ROCKY FLATS SITE REGULATORY CONTACT RECORD

Purpose: East Trenches Plume Treatment System (ETPTS) media removal and reconfiguration for air stripper treatment

Contact Record Approval Date: January 21, 2014

Figure 1

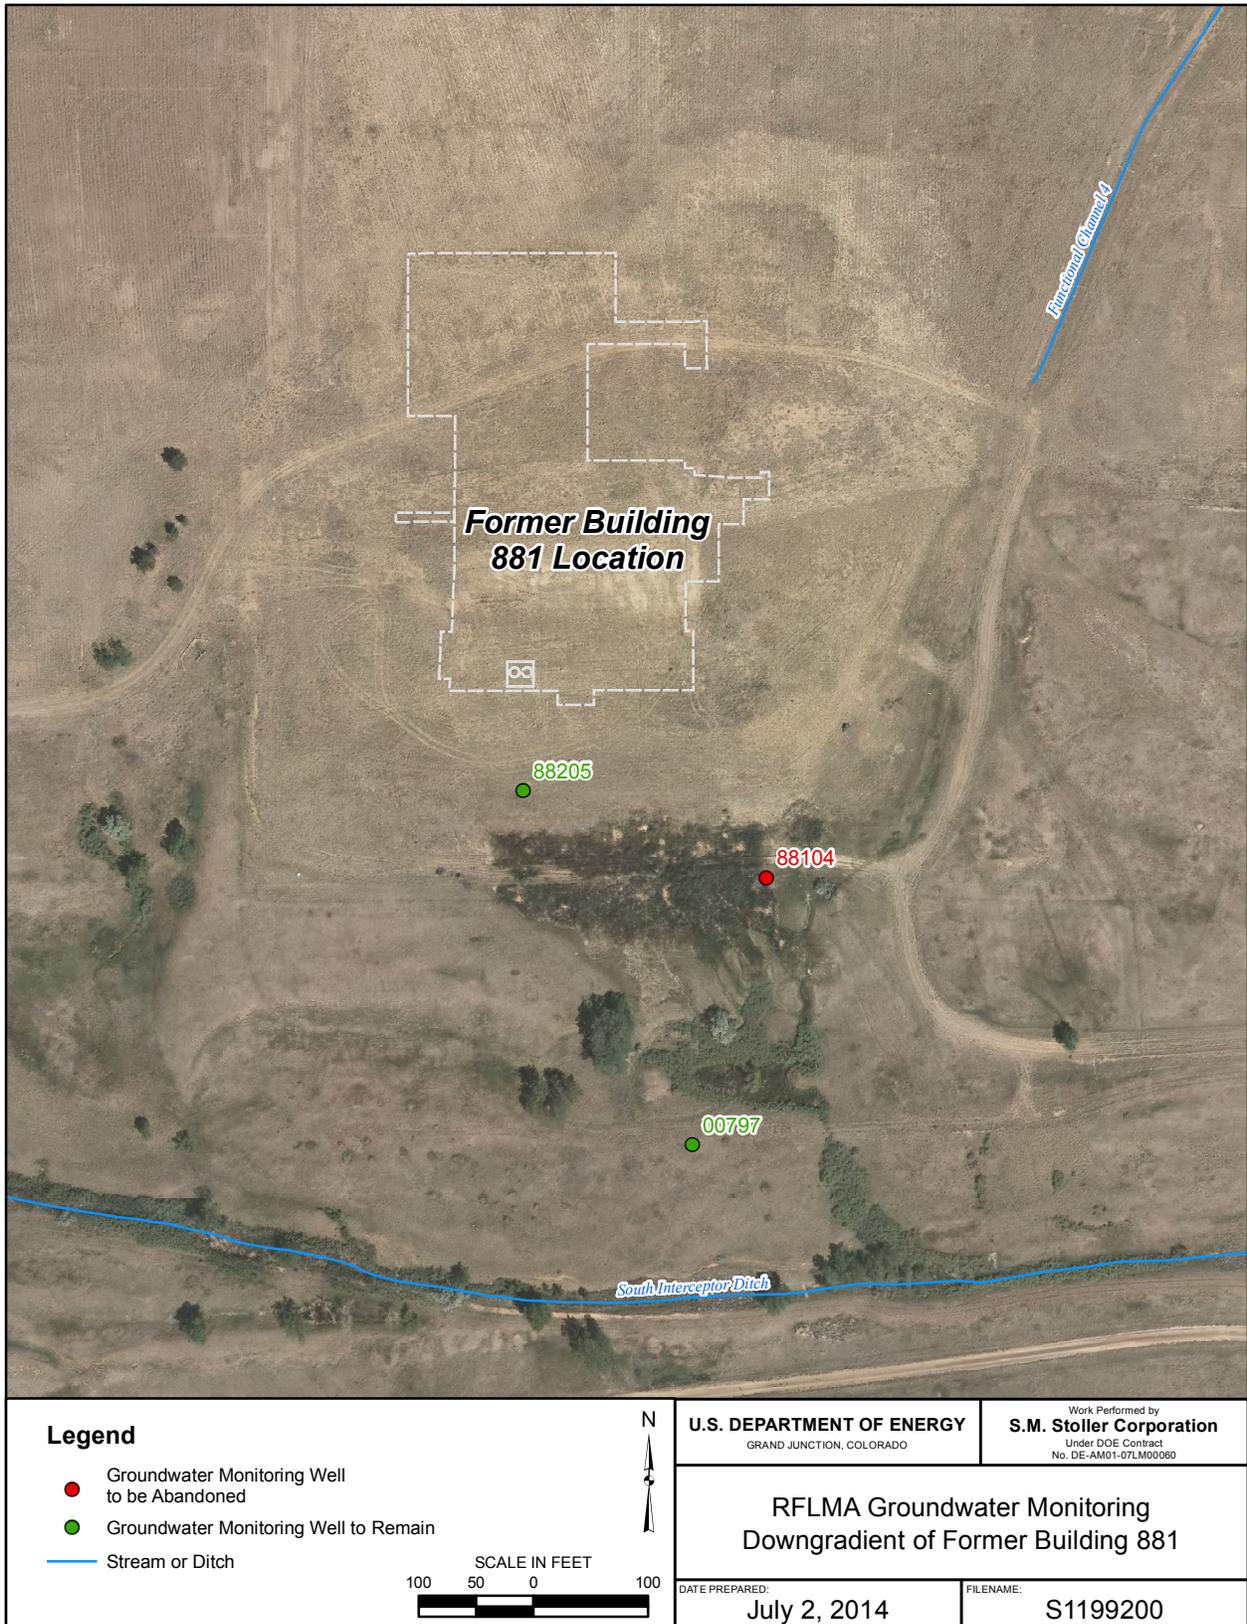
This condition and three primary response alternatives were discussed: (1) install a replacement well, (2) insert a smaller-diameter casing in the existing breached casing and continue to monitor this location until that inner casing also breaks, or (3) discontinue sampling and abandon the well. Recent data from well 88104 and the two closest wells that also monitor former B881, Evaluation well 88205 and Sentinel well 00797, were evaluated (see attached map for well locations).

- Well 88104 is damaged. This damage is likely worsening; no damage was indicated in the fourth quarter of 2013, but during the second quarter of 2014 the broken 2-inch-diameter casing only allowed objects smaller than 1 inch in diameter to pass, and a significant portion of the well has filled with filter-pack sand. Restoring functionality to this well using an inner casing would be a temporary fix until the inner casing breaks. Given that well 88104 is redundant, resources required to replace it could be put to better uses. The groundwater monitoring network would continue to effectively monitor groundwater downgradient of former B881 if well 88104 was abandoned and not replaced.

Consistent with RFLMA Part 5, “Regulatory Approach,” the RFLMA parties have determined that the above rationale is sufficient to abandon well 88104, in spite of not precisely meeting the RFLMA Attachment 2, Figure 8, “Sentinel Wells” Flowchart criteria. Therefore, well 88104 will be abandoned in place, per Volume 2 *Code of Colorado Regulations* 402-2, “Rules and Regulations for Water Well Construction, Pump Installation, Cistern Installation and Monitoring and Observation Hole/Well Construction.” When RFLMA Attachment 2 is next revised, Table 2, “Water Monitoring Locations and Sampling Criteria,” will be updated to remove well 88104.

Figure 1. OLF Soil Disturbance, Filling, and Grading Location

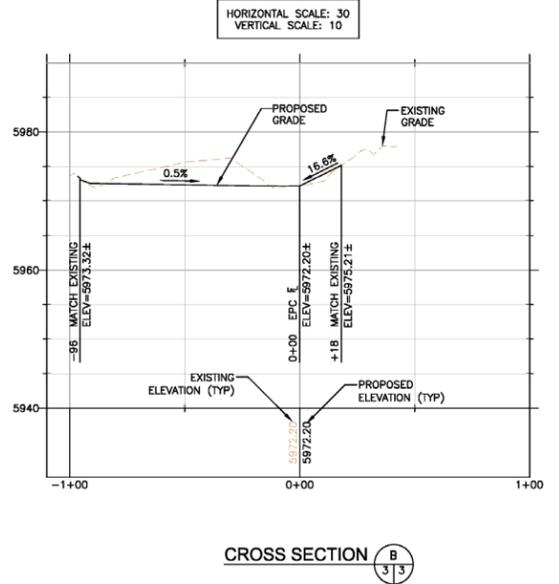
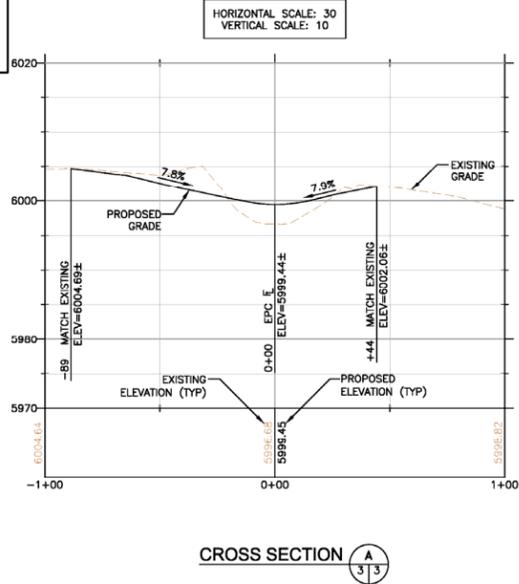
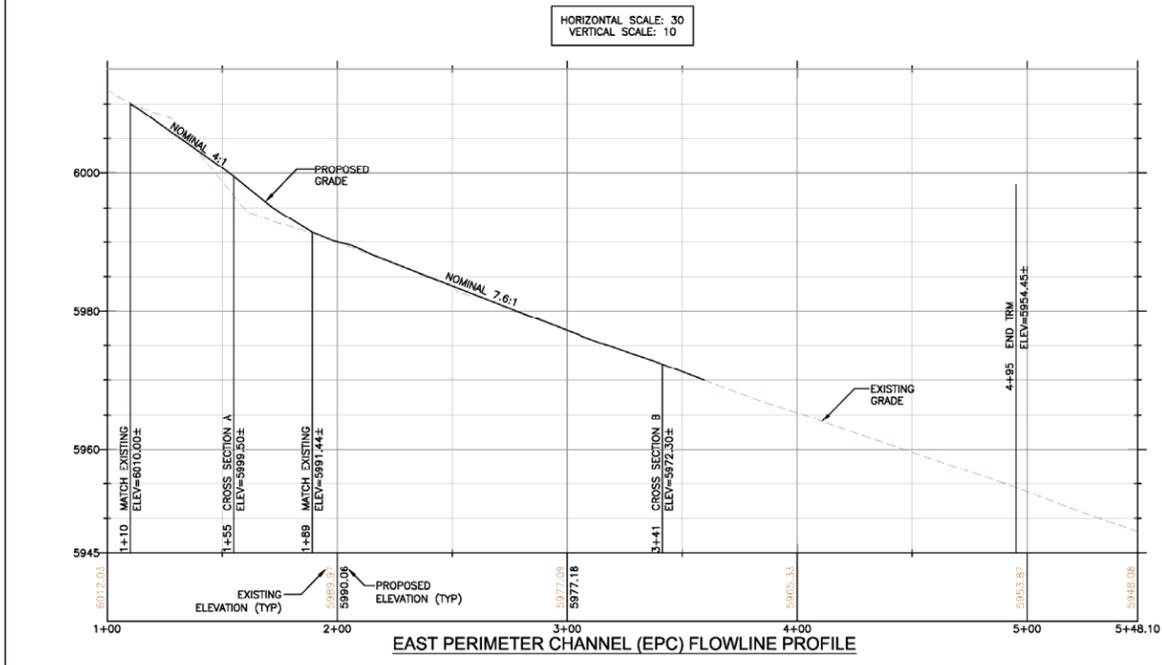
Discussion: DOE, CDPHE, and EPA met on August 5, 2014, to review the proposed update to the grading plan. The primary updates to the December 2013 grading plan are to cut back the ends of berms 4, 5, and 6 and taper the sides of the channel back to a more gradual slope. Figure 1 shows the location and anticipated aerial extent of the soil disturbance. The construction boundary is similar to the previous (December 2013) design, but soil disturbance is more extensive. There is a smaller area around the berm 4 flow line inside the “limit of waste” that will have new turf reinforcement material installed for erosion control. In October 2013 a slotted drainage pipe bedded in ¾-inch crushed drain rock was installed in the eastern end of diversion berm 4 as part of the initial response to the localized distress (see CR 2013-02), and this will be left in place. Another 4-inch slotted drainage pipe bedded in crushed drain rock will be installed between berm 5 and 6 to drain water from Seep #2/3 into the EPC. The excess soil will be distributed inside the COU as shown in Figure 2. No intrusive work will be performed within the waste footprint boundary.

Contact Record 2014-09 Figure 1 shows the location and the lateral and vertical extent of the excavation and soil disturbance. The slopes of the western side of the EPC between berms 5 and 6 will not be restored to the existing grade, therefore reducing or removing the 2-foot soil cover; however, this area is outside the “limit of waste.” The soil disturbance, regrading, and drainage feature installation work will not change the 2-foot-thick soil cover within the limits of the buried wastes. The material (Rocky Flats Alluvium) excavated from the cut areas will be used as fill in the fill areas. The excess soil will be distributed at designated locations in the COU as shown in Contact Record 2014-09 Figure 2.

The OLF is former IHSS 115. The OLF has a 2-foot-thick soil cover over the location of the disposed waste materials and clean Rocky Flats Alluvium fill surrounding the waste materials for the placement and configuration of storm water and seep water management features. Limits of the waste area are shown in Contact Record 2014-09 Figure 1.

Resolution: CDPHE has review information regarding the proposed soil disturbance and excavation and, after consulting with EPA, has approved the proposed activity and the proposed grading plan. CDPHE has determined that the proposed activity will not compromise or impair
